Angio to Cath. Lab Renovation

ADDENDUM #2

TCMC Angio to Cath Lab

BID ADDENDUM NO. 2

A4-12

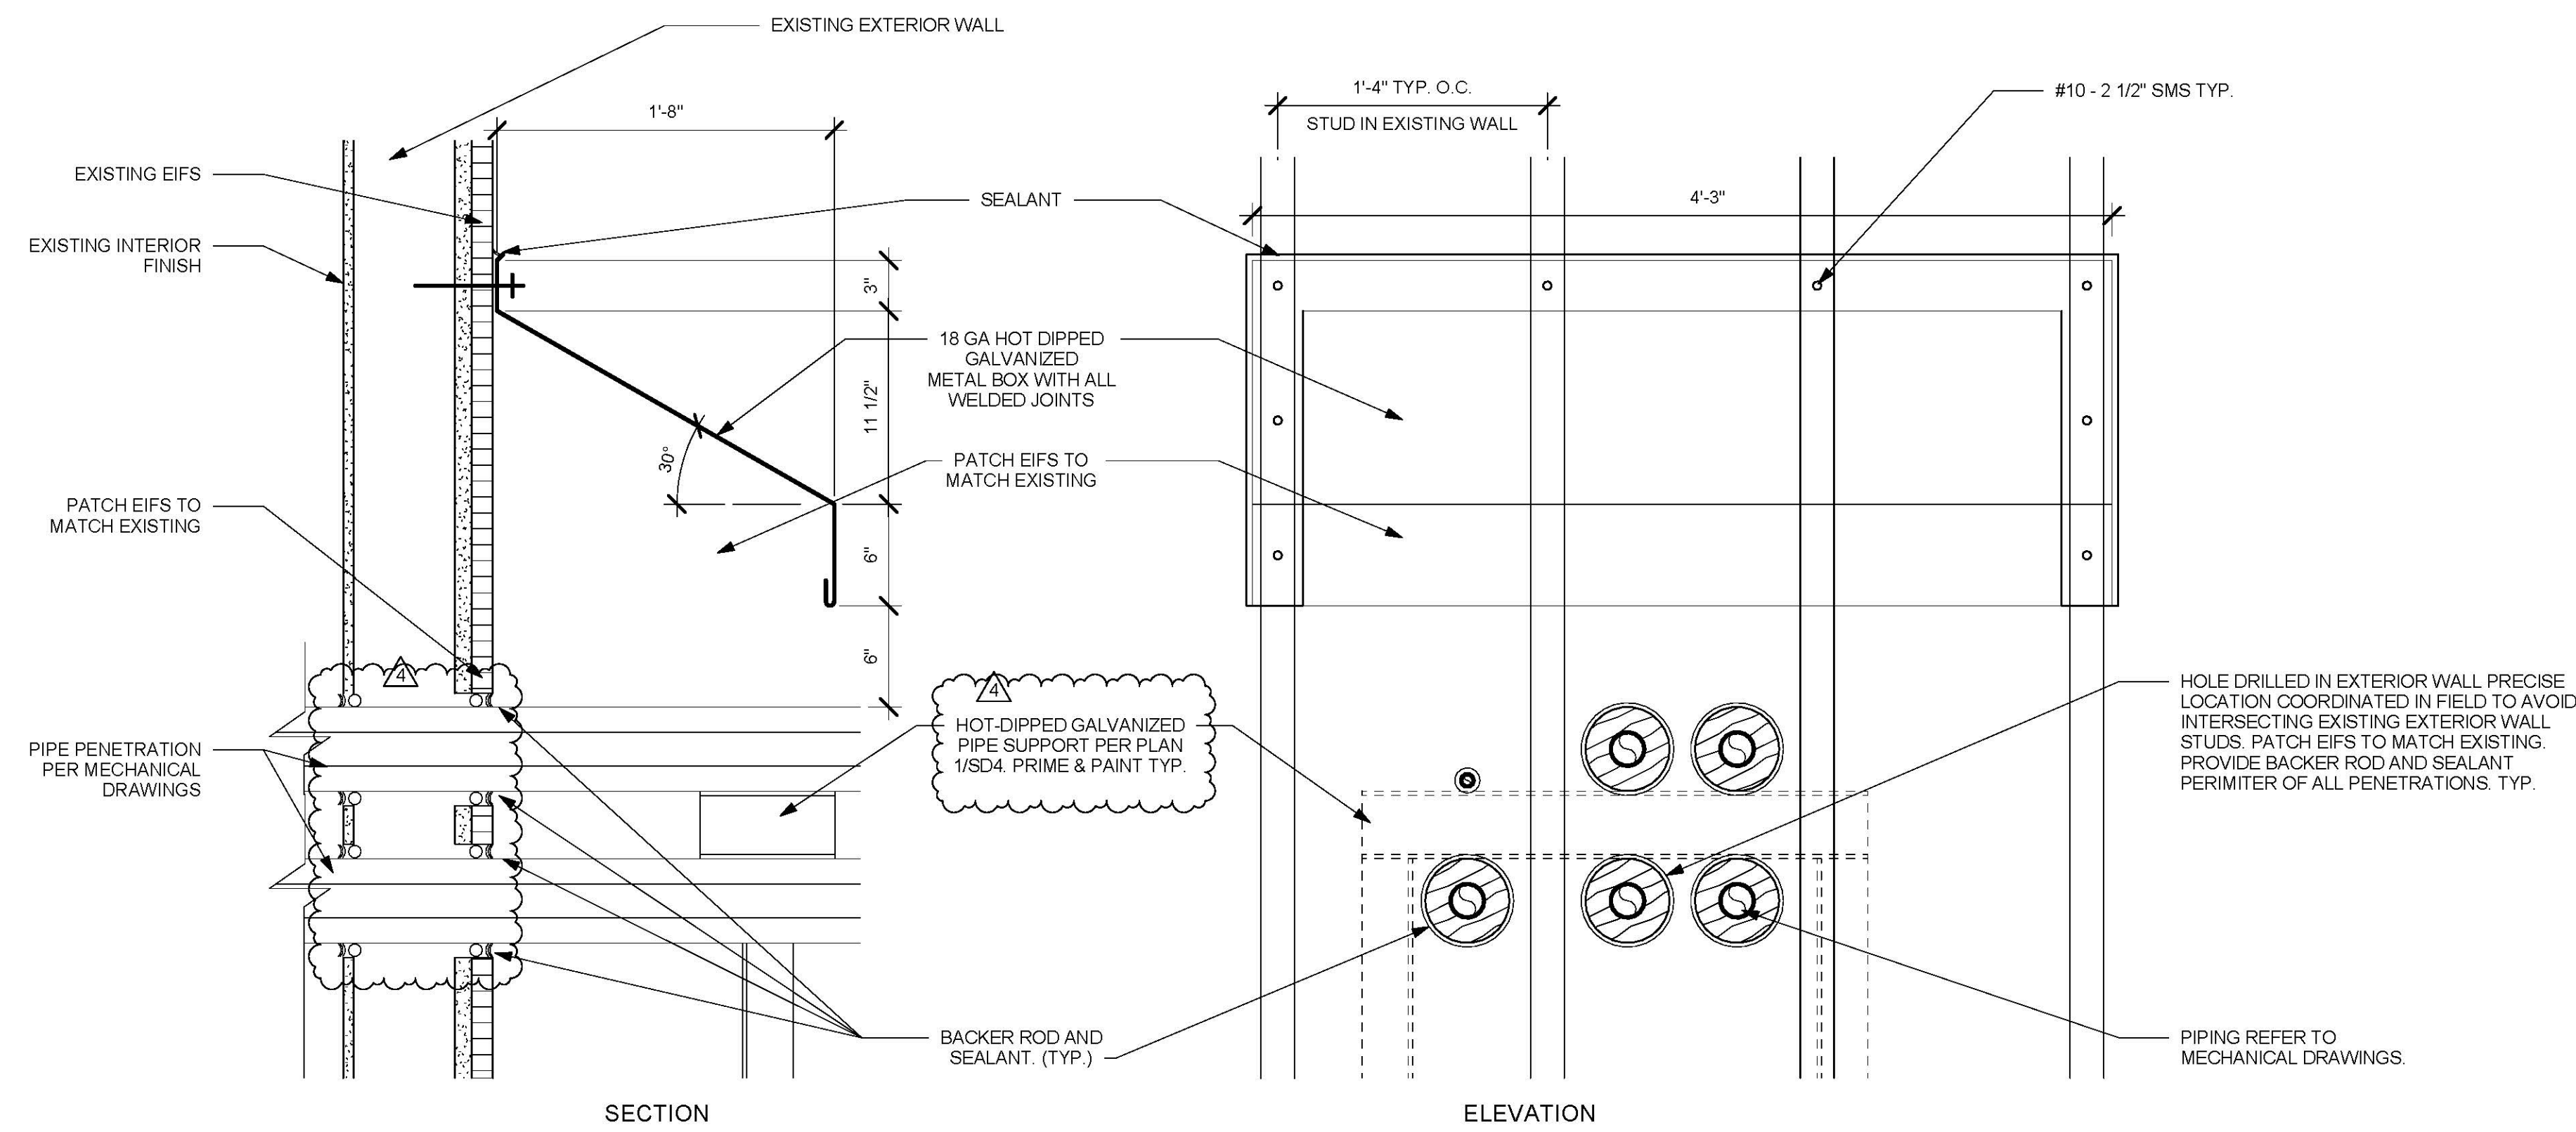
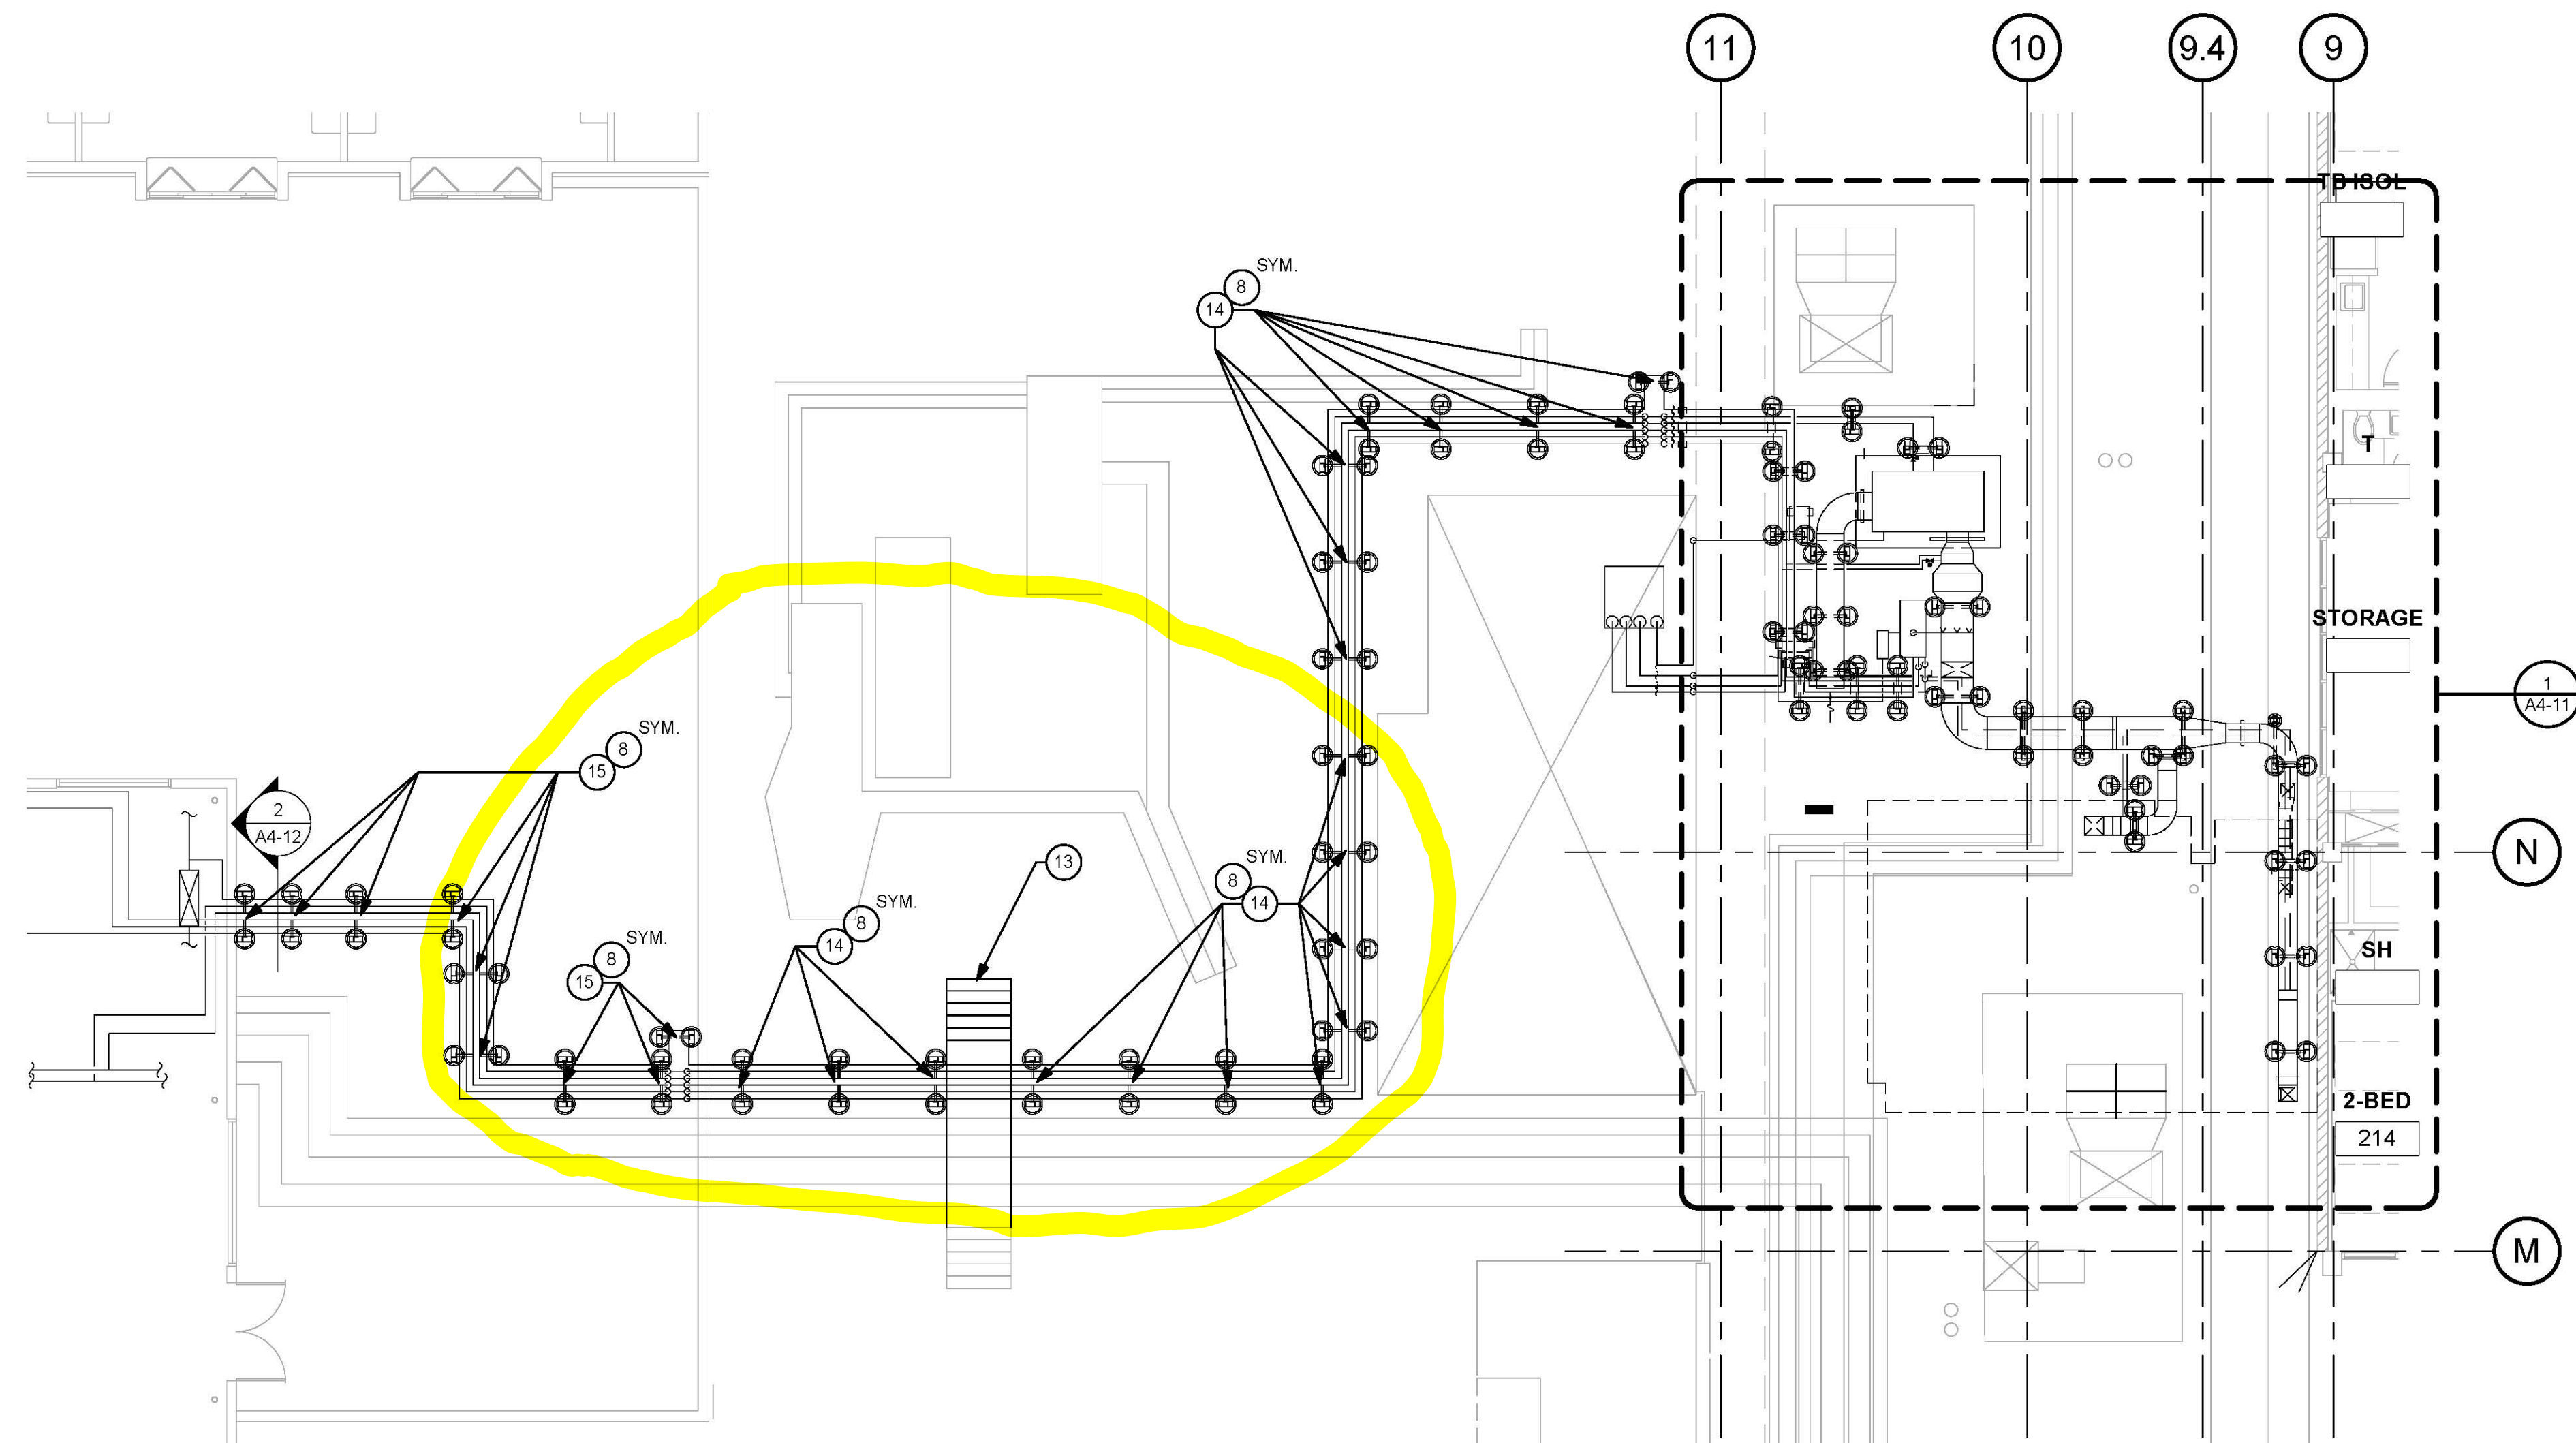
Note 13 on sheet A4-12 states that the roof stair is to be modified.
There is no note on how to modify this stair.
We need a detail and measurements of modification to proceed.

Proposed Solution:
Please provide a detail on stair modification.

See the attached PHP Systems/Design , Crossover , Specification and Technical Information Sheet.
Contact:
Jesse Valles
PHP Systems Design
5534 Harvey Wilson Drive
Houston, TX 77030
800.797.6585
713.678.9239
FAX: 713.678.9289
phpsd.com

- 13 EXISTING STAIR TO BE RETROFITTED TO SPAN OVER NEW PIPES. REPLACE TOP HANDRAIL, INTERMEDIATE HANDRAIL, BOTTOM SUPPORT RAILS AND OTHER HORIZONTAL MEMBERS WITH LONGER SIMILAR 3-SIDED TUBULAR SHAPED 12 GA HOT DIP GALVANIZED CHANNELS PER ASTM A 123. ADD NUMBER OF 18 GA STEEL WALKWAY PLANKING TO SPAN WALKWAY. TOTAL MAX LENGTH OF TOP PLATFORM BETWEEN SUPPORTS NOT TO EXCEED 120".
- 14 USE NON-THRU-BOLT ANCHORAGE OPTION. SEE DETAIL 1/SD5.
- 15 USE NON-THRU-BOLT ANCHORAGE OPTION. SEE DETAIL 3/SD5.
- 16 NEW HUMIDIFIER. SEE DETAIL 2/SD5 FOR ANCHORAGE.
